Office Action Summary

10/811,102

DETAILED ACTION

FIG. 1

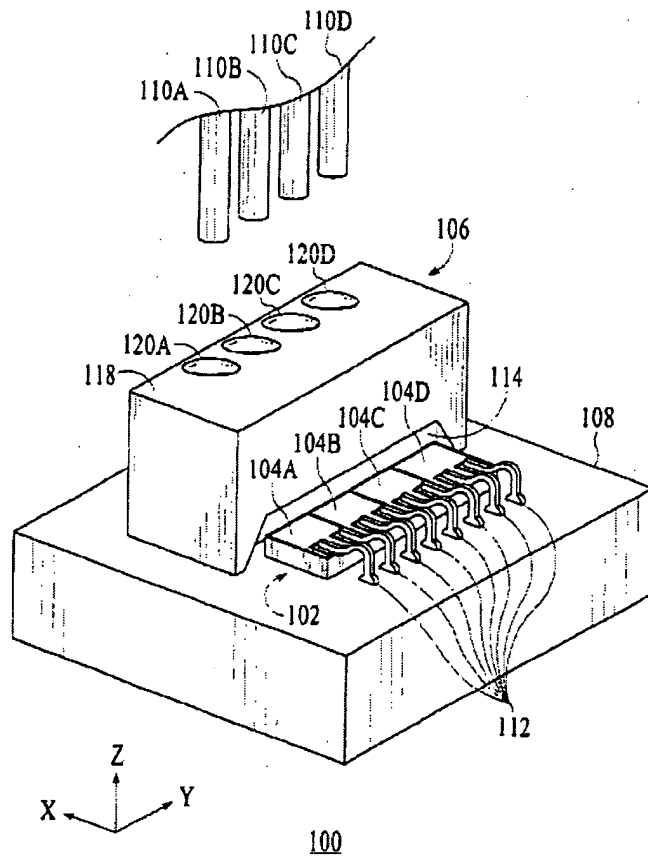
In re claims 1, 4, 8, 13, 14, 27, and 29, Wilson discloses an electrooptical module (100), comprising:

at least two electrooptical components (104A-104D) supported by a top surface of a common carrier (108) and operably coupled to an one optical waveguide (110A-110D), wherein:

the optical waveguide (110A-110D) is disposed above the top surface of the carrier (108);

the at least two electrooptical components (104A-104D) each are in an optical free-beam connection with the optical waveguide (110A-110D) by means of at least one lens (120A-120D);

as disclosed by Wilson at column 4, lines 17-19, the output lights from each of the lenses (120A-120D) may propagate "off-axis" and, therefore, Wilson clearly suggests the optical axis of each of the light beams could converge into the same waveguide;

wherein the at least two electrooptical components (104A-104D) comprises edge-emitting lasers arranged in a row (column 2, lines 60-62),

the electro optical module (100) further comprising a supporting element (106) that has reflective coating (116, shown in Fig. 2) assigned to the laser or the lasers, the supporting element (106) and the reflectively coating (116) being arranged in such a way that they reflect the light emitted by the laser or by the lasers (104A-104D) about 90 degrees onto the respectively assigned lens (column 3, lines 29-36). Figure 1 of Wilson is reproduced below.

In re claim 2, the use of an "optical squint angle" for the lenses (120A-120D) is clearly suggested in Wilson's disclosure at column 4, lines 15-20 in view of Fig. 3. Furthermore, the waveguides (110A-110D) are arranged perpendicular to the top surface of carrier (108) as seen in Fig. 1.

In re claim 5, the lenses (120A-120D) are arranged on the supporting element (106) and located spatially above the electrooptical components (104A-104D) as seen in Fig. 1.

A modified Figure 1 of Trezza is reproduced below. Additional labeling has been provided to Figure 1 of Trezza to more clearly show the claimed features.

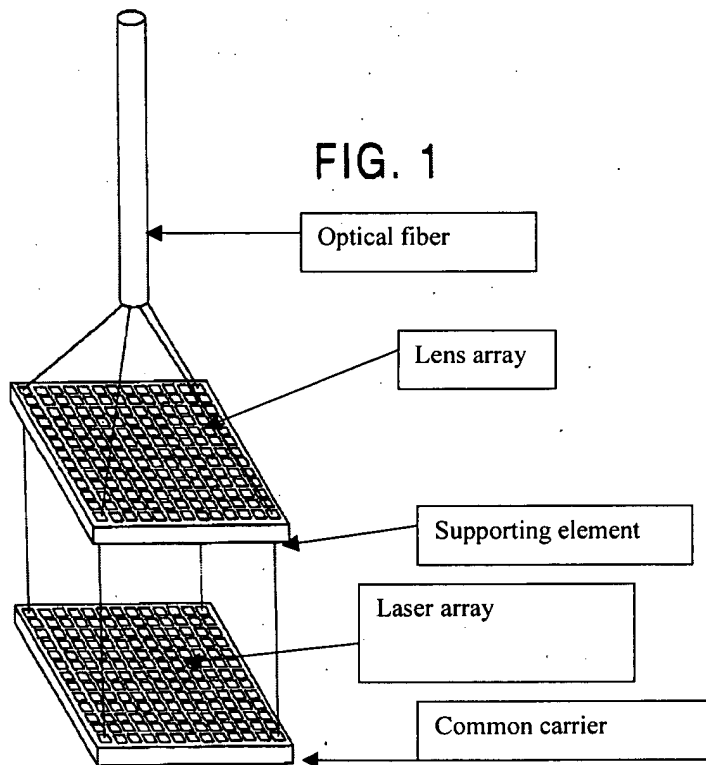
In re claims 1 and 8, Trezza discloses an electrooptical module (e.g., Figures 1-3), comprising:
at least two lasers supported by a common carrier and operably coupled to at least one optical fiber, wherein the optical fiber is disposed above the carrier;

the at least two lasers are in an optical free-beam connection with the optical fiber by means of at least one lens;

all the light from each of the lenses intersects the optical fiber at about the same point;
and

In re claims 2-5, 11-13, and 25, the specific limitations are clearly apparent from Trezza's disclosure at column 1, line 42 to column 2, line 21 in view of the modified Fig. 1 shown above.
